# SYSTEM SUPPORT DIRECTIVE

SSM- ASR9- 002

## TRANSMITTER POWER INTERRUPT AND BLOWER MOTOR FUSE

February 6, 1998

FIGURE. A13TB2

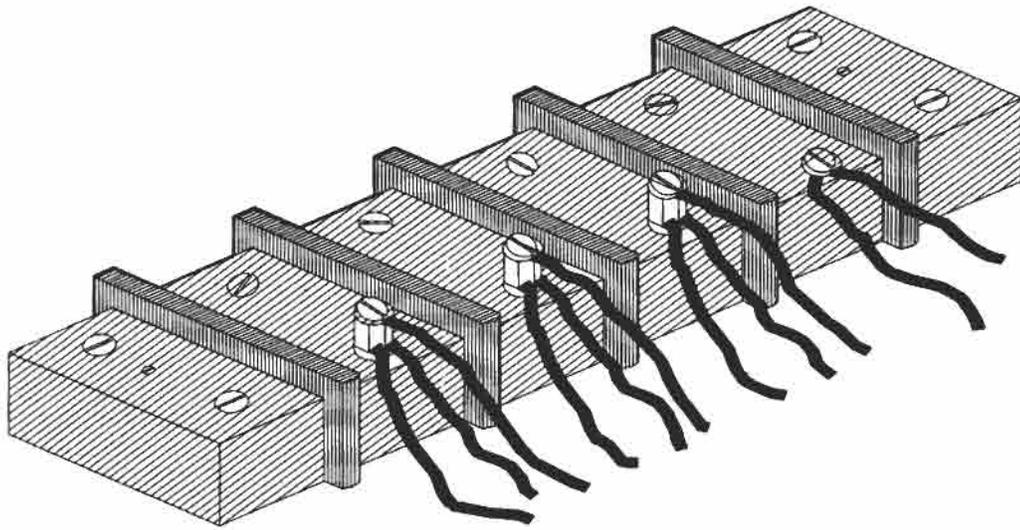
- q. Connect the input power cables labeled A13 TB1-1, A13 TB1-2, A13 TB1-3, and A13 TB1-4 to TB1 on the left side of the power monitor.
- r. Connect the output power cables to A13 TB2. For the cables connected to A13 TB2-1, A13 TB2-2, and A13 TB2-3, the fan-out for the three lugs makes it necessary to separate one of the cables. This will be accomplished by placing a hex standoff (figure 1-2 in appendix A) between the cable lugs. Remove the screw from the terminal board. Mount two of the cables to TB2 with the hex standoff and mount the third cable on top of the standoff using the screw, which was removed. (As seen in appendix A, figure.)
